STAFF ANALYSIS

CASE NO.:	Z-26-1247887	File ID #: 2026-0449
Address:	705 & 711 Hillmont Avenue, Decatur 30030	Commission District: 04 Super District: 06
Parcel ID(s):	15 248 07 017 & 15 248 07 020	
Request:	Rezone properties from the C-1 (Local Commercial) Zoning District and to the R-60 (Residential Small Lot -60) Zoning District to construct a new single-family residence.	
Property Owner(s):	William McGrier	
Applicant/Agent:	Ray Bachan / My Next Home Pro, LLC	
Acreage:	0.15 acre	
Existing Land Use:	Single-Family Home	
Surrounding Properties:	North: Commercial (within City of Avondale Estates) South: R-75 East: R-75 West: R-75	
Adjacent Zoning:	R-75 (Residential Small Lot-75)	
Comprehensive Plan:	Commercial Revitalization Corridor (CRC) Consistent <input checked="" type="checkbox"/> Inconsistent

STAFF RECOMMENDATION: APPROVAL, WITH ONE (1) CONDITION.

SITE
PLAN

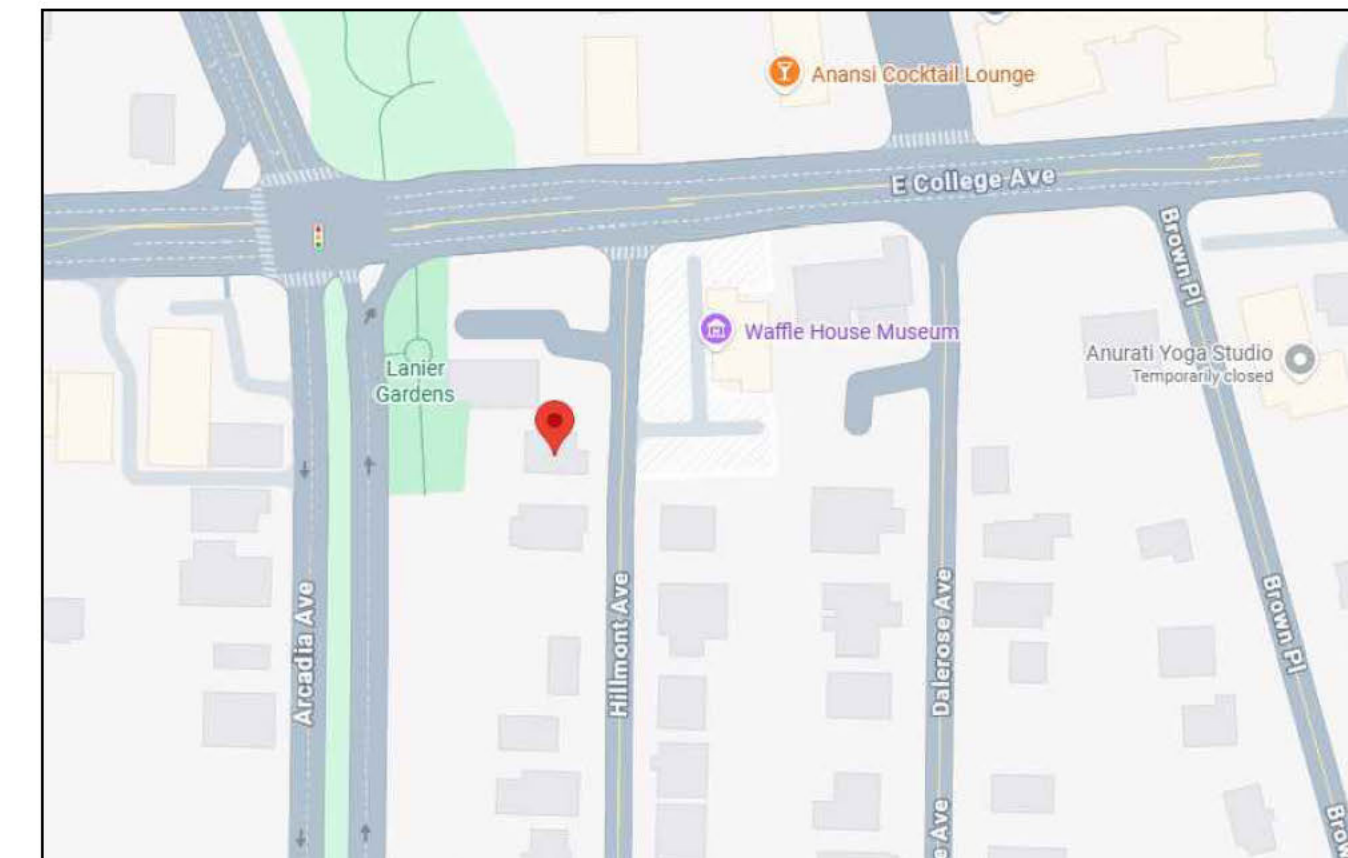
The proposed site plan and architectural plans submitted by the applicant displays a modern three (3)-story single-family house that appears to meet R-60 dimensional requirements of Section 27-2.8.3 (Table 4.1). The house plans indicate a 3,639 square-foot heated area, an attached 474 square foot unheated garage, a 217 square-foot covered rear patio, and a partial roof deck patio on the 3rd floor of the home. Section 27- 2.8.3 and Table 4.1 of the Zoning Ordinance states that the minimum lot size is 15,000 square feet, with a maximum lot coverage of 35 percent. The minimum house size is 2,000 square feet heated along with a maximum of 35 feet, with setbacks of 10 feet in front (with alley access), 7.5 feet on each side, and a 30-foot rear setback. There are no proposed variances.

1. A 5-foot landscape strip and 5-foot sidewalk must meet the requirements of Section 5.4.3 (Streetscape Elements and Dimensions) of the Zoning Ordinance, prior to the issuance of the Certificate of Occupancy (C/O).

SHEET TITLE:
 PROPOSED
 FRONT ELEVATION

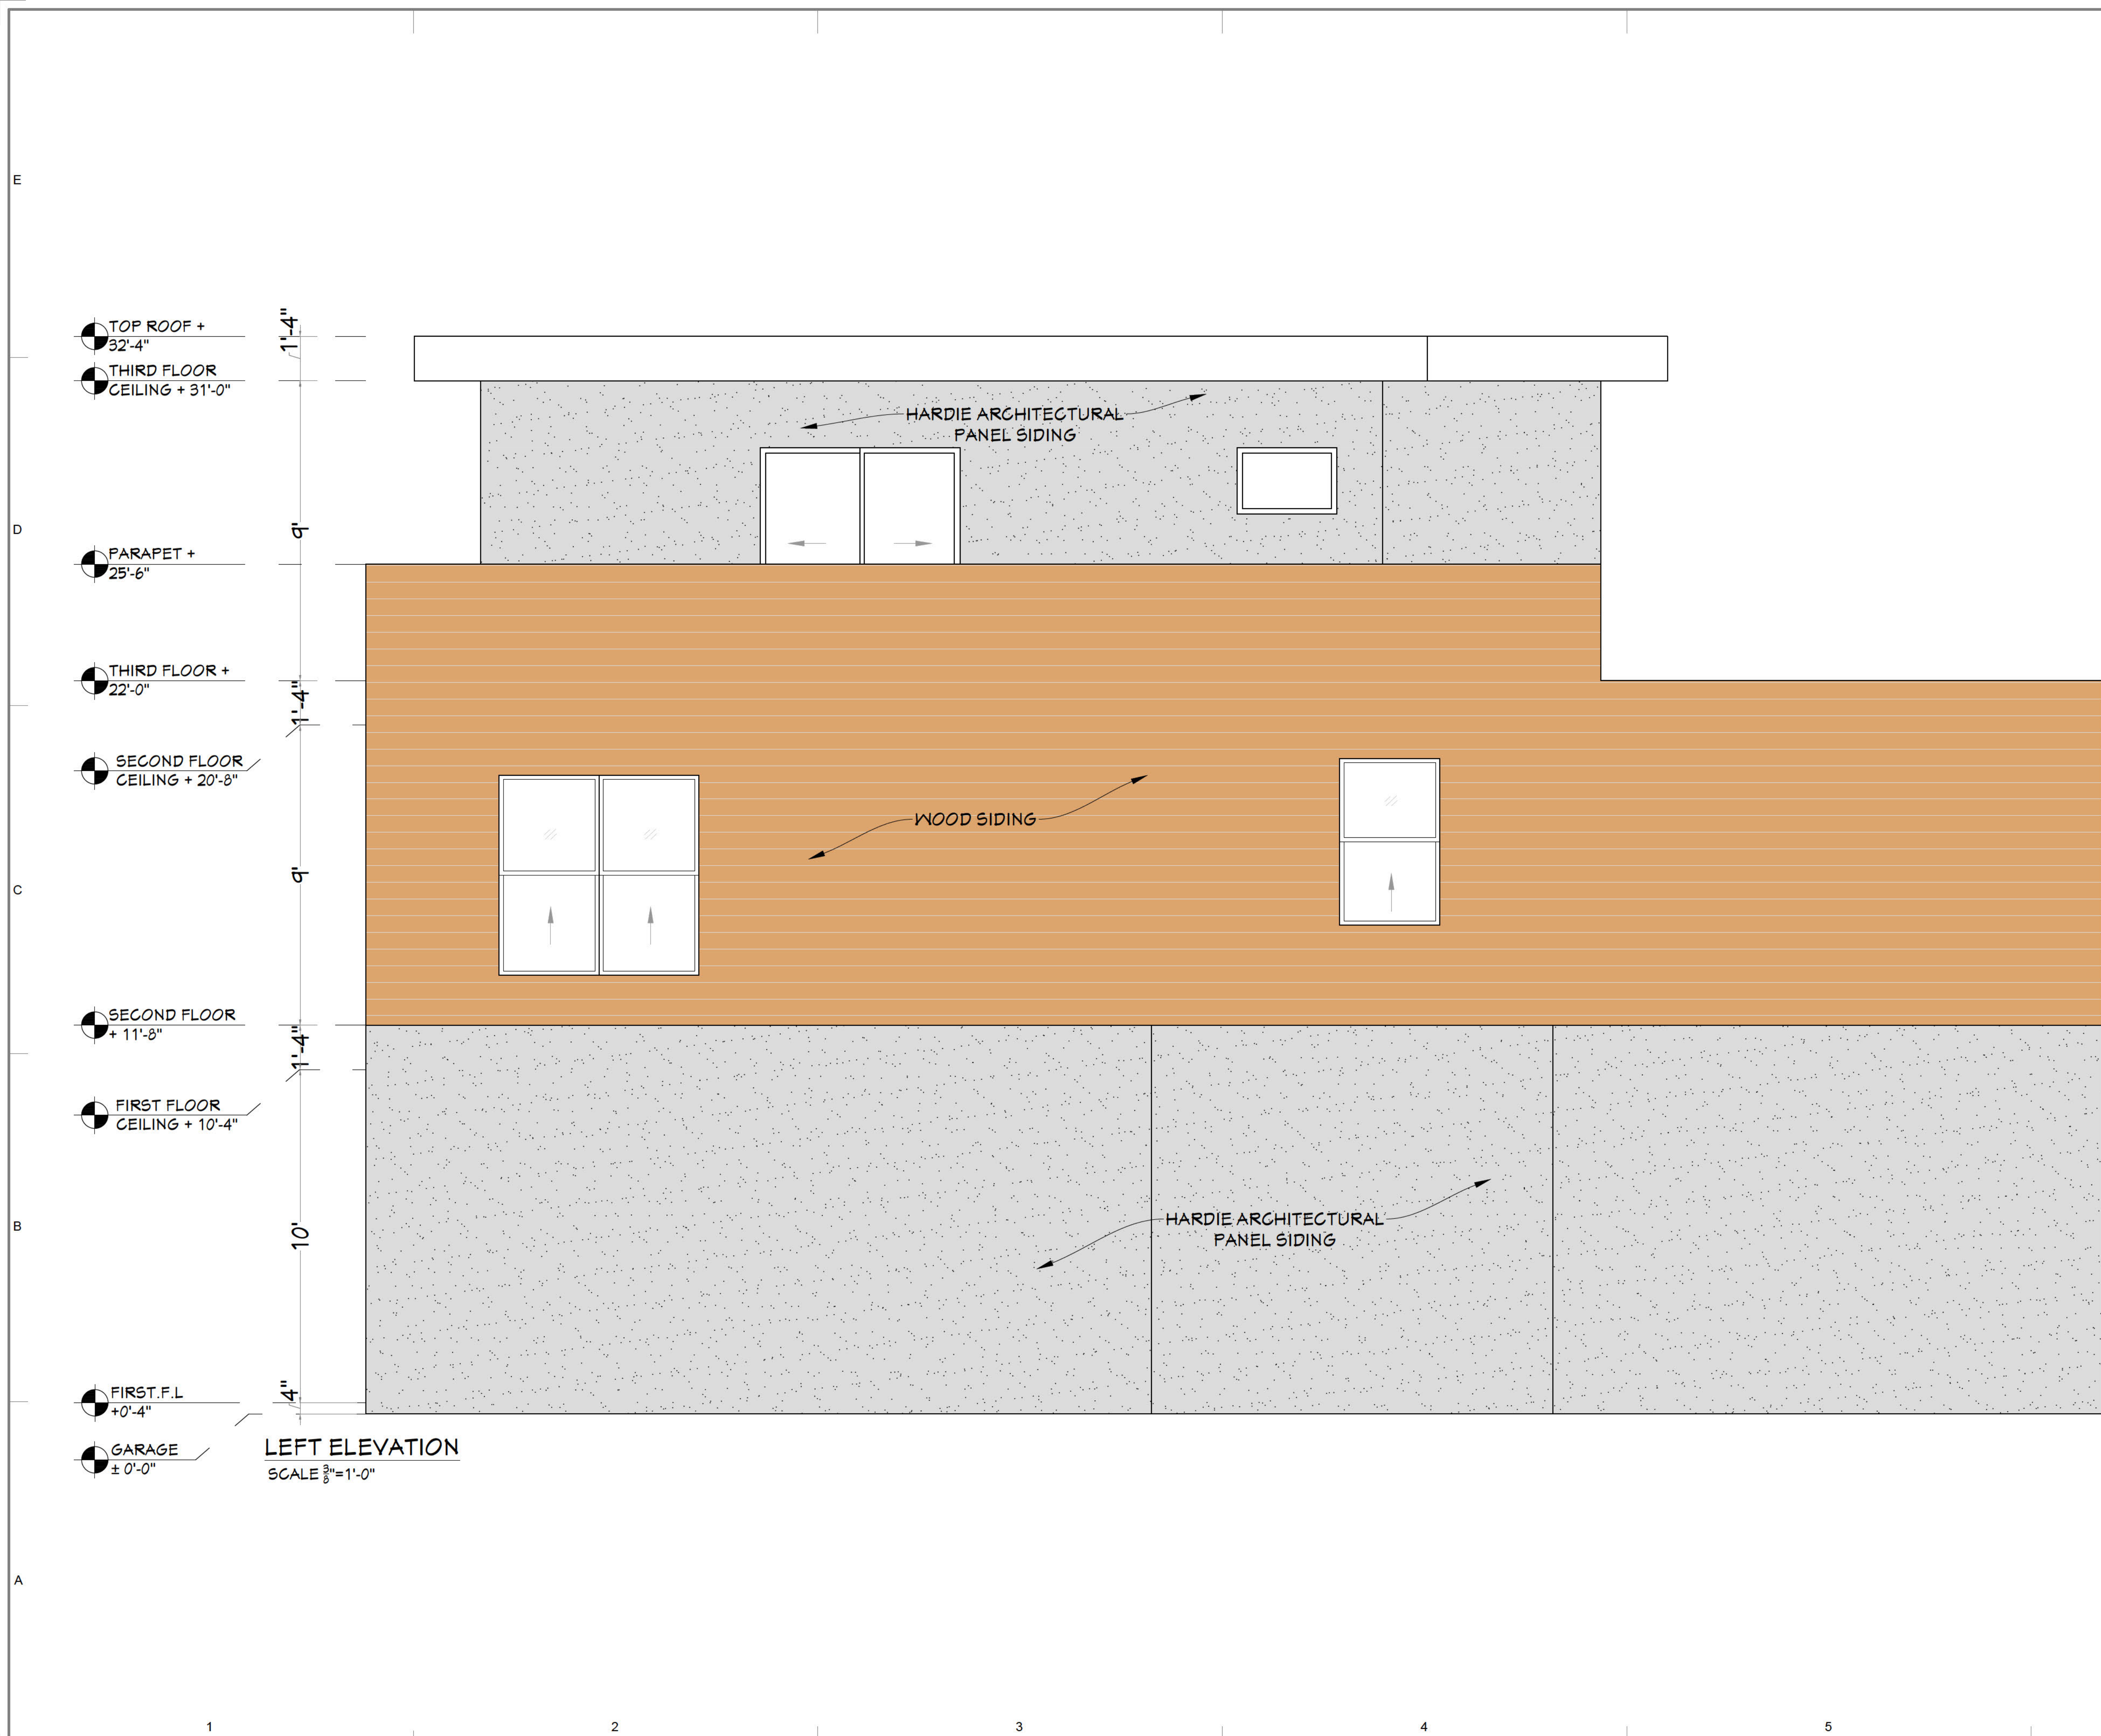
While the rezoning is consistent with the neighborhood, the proposed architectural design may not align with the existing development pattern along Hillmont Avenue. Staff would suggest an architectural design that better aligns with the homes along Hillmont Avenue.
